Evaluation of Construction and Plugging Procedures for the San Joaquin Renewables Class VI Project

In June 2022, EPA provided questions presented in *blue italicized text* to San Joaquin Renewables (SJRenew) about the Injection Well Plugging Plan (5_Injection--Well--Plugging--Plan) submitted as part of SJRenew's Class VI permit application (dated October 13, 2021) for the proposed SJRenew Class VI geologic sequestration (GS) facility. In response, SJRenew provided updated Injection Well Plugging Plan (Attachment D_Injection Well Plugging Plan_090722), Narrative (Attachment A_SJR_Narrative_090822), Post Injection Site Care Plan (Attachment E_PISC_090722), and Testing and Monitoring Plan (Attachment C Testing and Monitoring Plan_090722) documents that incorporated updated well construction, plugging, and abandonment information. SJRenew also provided a document summarizing their responses (Response_090822) to EPA on September 8, 2022. EPA's evaluation of how these updated plans address its questions and requests for revisions and additional information are presented in *red italicized text* below.

Figure 3-1

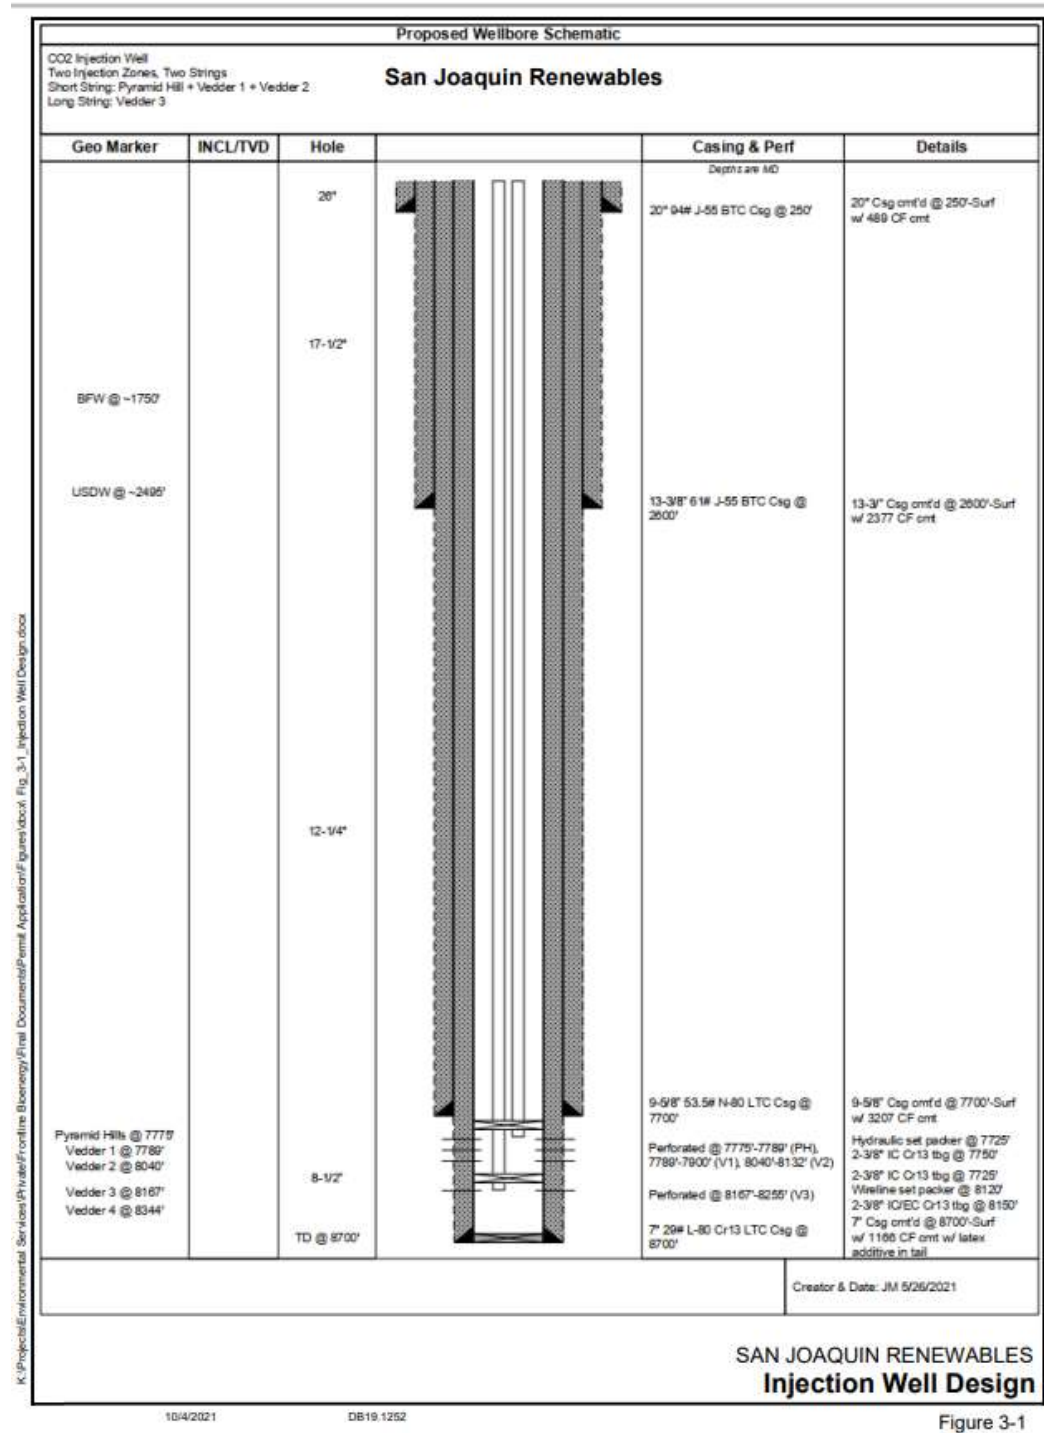
SJR did not submit a separate well construction plan, but Section 3 of the permit application narrative describes the proposed injection well construction design. The proposed injection well design schematic is presented in Figure 3-1 of the narrative. The figure shows the position of the various casing strings, tubing, packers, and perforations to be implemented in the SJR-I1 injection well.

The narrative states that “intermediate casing will be placed across fresh water and USDW zones, with a shoe at 2,600 ft bgs” (p. 30); per the Class VI Rule, the surface casing must be set and cemented to the depth of the lowermost USDW. The proposed depth of the shoe appears to be appropriate based on information in the narrative about the depth to the USDW.

- *The narrative (pg. 31) states that “The dual injection string design ... using 2 3/8” tubing may restrict certain logging options to special smaller diameter logging tools.” Please confirm that SJR will be able to perform the required mechanical integrity tests (MITs), or other tests given the small tubing diameter.*

- *Please include the continuous recording devices that will be installed to monitor injection pressure, rate, and volume (as described in the Testing and Monitoring Plan) on the injection well schematic.*

- *Please confirm that the surface casing extends to through the base of the lowermost USDW, as required per 40 CFR 146.86(b)(2).*

- *Please clarify that the surface (not intermediate) casing will be set and cemented to the depth of the lowermost USDW.*

SJRenew responded that their drilling subcontractor (Driltek) does not anticipate any issues conducting MITs or other required tests through the smaller diameter tubing. The response is acceptable.

The pressure, rate, and volume monitoring equipment have been added to the revised Testing and Monitoring Plan in Section 2.2 (pg. 3), summarized in Table 1, and to the well schematics provided in Appendix B. Additionally, example product cut sheets of the monitoring equipment are also included in Appendix B. The response is acceptable.

SJRenew responded that the surface casing will be installed through the base of the lowermost USDW (~2,495 ft) to a depth of 2,600 ft. These details are also included on the injection well schematic provided as Figure 5-1. The response is acceptable.

Section 5.2 states that the surface casing will extend through the lowermost USDW; this is supported by the injection well schematic provided as Figure 5-1. The response is acceptable.
